MEMORANDUM FOR SUBMISSION TO CHAIRMAN'S MEETING

FROM: OPERATING MANAGER (RAILWAYS)
SUBJECT: LEICESTER SQUARE STATION: PROPOSED NEW
INTERCHANGE SUBWAY.
DATE: 4th August, 1938.

SUBJECT: LEICESTER SQUARE - PROPOSED INTERCHANGE SUBWAY

FROM:- GENERAL MANAGER (RAILWAYS).
SUBJECT:- LEICESTER SQUARE PLATFORM CONGESTION
(MORDEN-EDGWARE LINE).
DATE:- 16TH APRIL, 1937.

LEICESTER SQUARE PLATFORM CONGESTION (Morden - Edgware Line)

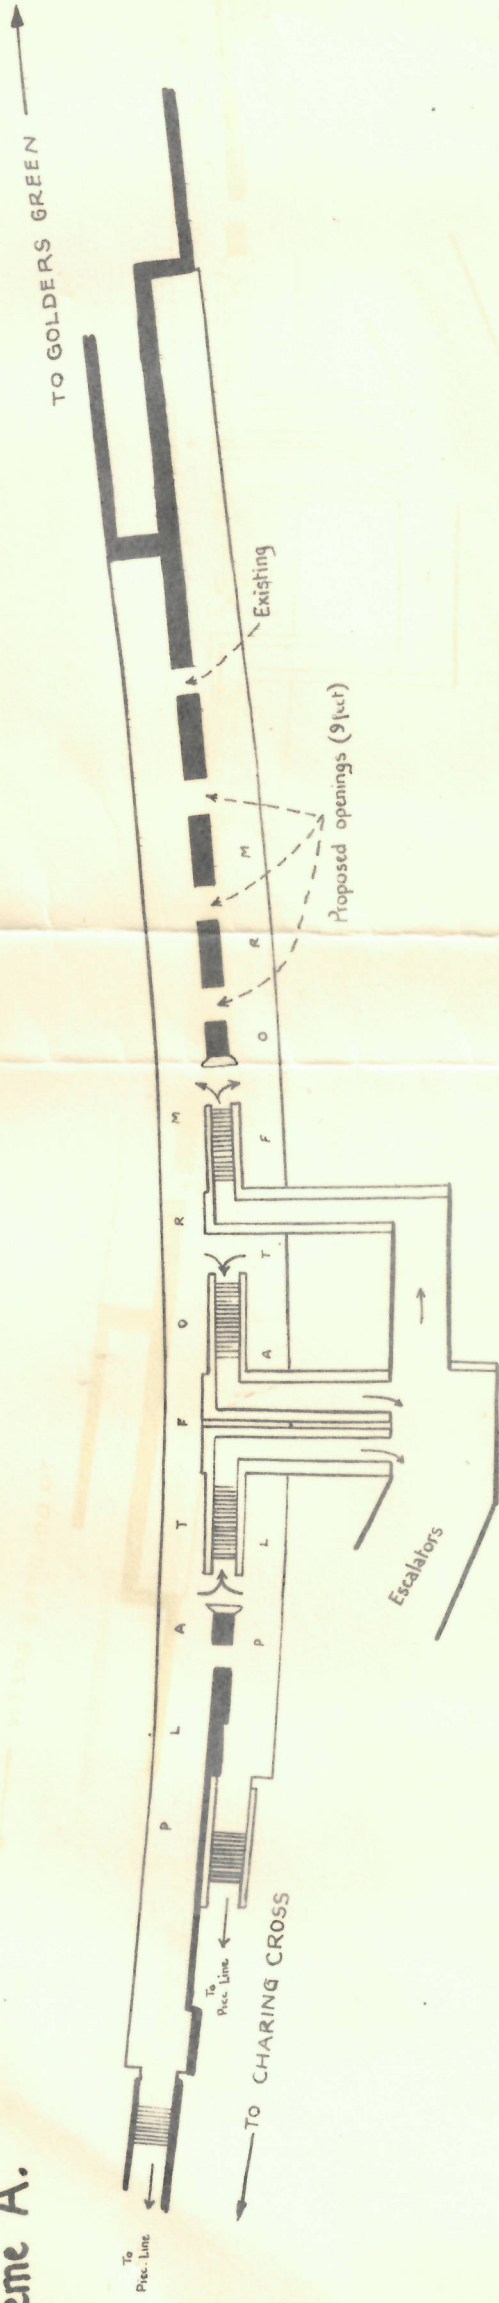
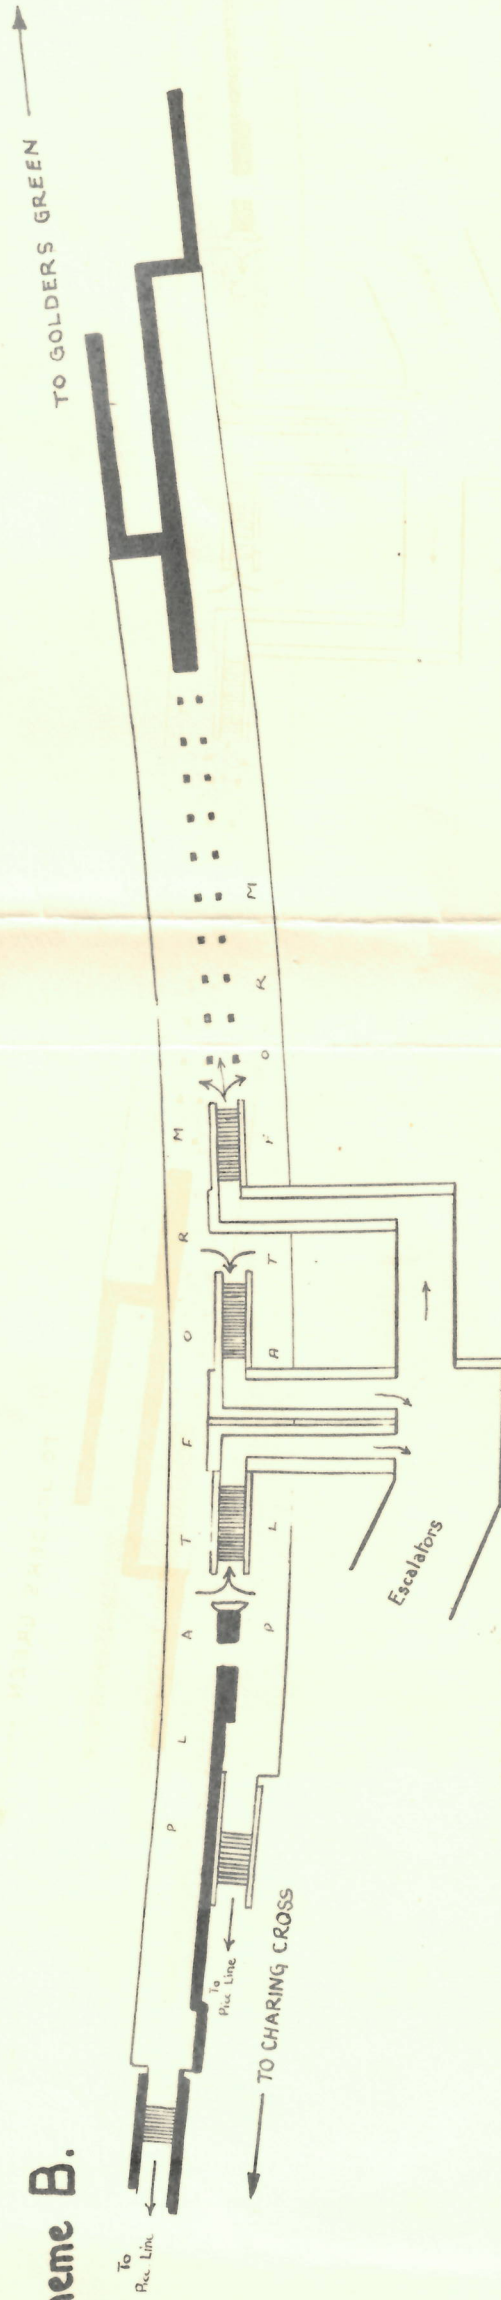
These platforms, which were narrowed from 11'0" to 9'3" over about one-third of the length of the platform, to enable the escalators to feed into the centre of station, are proving to be inadequate: the congestion in the evening and Saturday afternoon peaks is becoming serious. The trouble is not only because of the narrowed platforms but that, like Tottenham Court Road station on the same line, where a relief passage was driven between the platforms, the traffic is too much for existing platform widths.

- (a) By inserting three 9'0" cross passages between the stairs and north headwall.
- (b) By continuing the present scheme of columns to the north headwall and opening out.

Either method would make the north end of the platforms more convenient for passengers, thereby spreading the volume. Sketch enclosed shows both methods, and it is recommended that the Engineers should now proceed to study the problem and advise. Method (b) is the better one so far as the traffic is concerned.
